UNITED STATES PATENT AND TRADEMARK OFFICE

10/573,214

Office Action Summary	Application No.		Applicant(s)	
	10/573,214		NANJYO ET AL.	
	Examiner		Art Unit	
	ILYA Y. TREYGER		3761

DETAILED ACTION

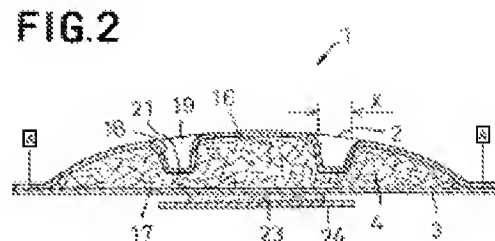
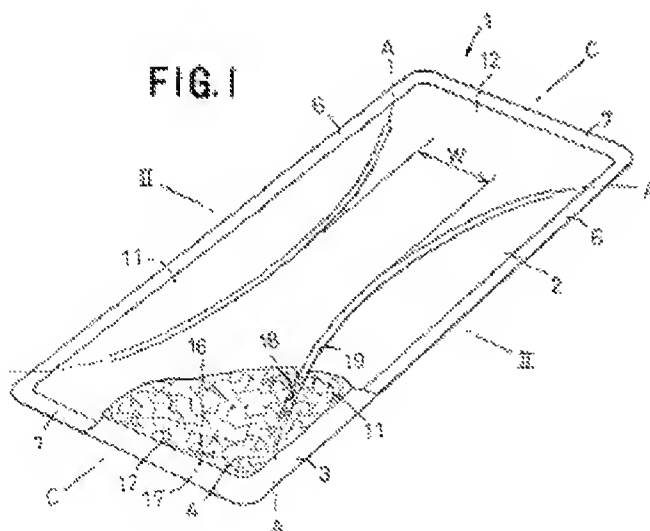
However, the separate description of portions does not preclude the portions from being physically integral that in the instant case has been supported by Applicant's Fig. 2 which is substantially identical to Fig. 2 of Shimoe.

15. In Re claims 1,3-4, 6, 10, 14, and 18, Shimoe discloses the sanitary napkin (absorbent article) 1 (Figs. 1 and 2) comprising a liquid-pervious topsheet 2 (Figs. 1 and 2), a liquid-impervious backsheet 3 (Figs. 1 and 2) and a liquid-absorbent core 4 (Figs. 1 and 2) disposed between the topsheet 2 and the backsheet 3 (Col. 3, ln. 3-6); the topsheet 2 is formed with a pair of second grooves (leakage preventing grooves) 19 depressed and curved in coincidence with the first grooves 18 (Col. 3, ln. 21-24; Figs. 1 and 2); wherein the leakage preventing grooves 19 (Fig. 2) are deeper than a thickness of the middle-height portion and reach the standard portion absorbent body (See Fig. 2); wherein the thinned portion A (Fig. 2) obtained by thinning the middle-height portion by press is formed on outsides of the leakage preventing grooves 19 (Fig. 2); wherein the middle-height portion is formed between front and rear lines W (Fig. 1) fully capable to be a folding lines for folding the absorbent article in three at the time of individual packaging; and wherein the thickness of the middle-height portion absorbent body is 1 to 15 mm (Col. 3, ln. 35, 36), what encompasses 1-3 mm as claimed (claims 6, 10, 14, and 18).
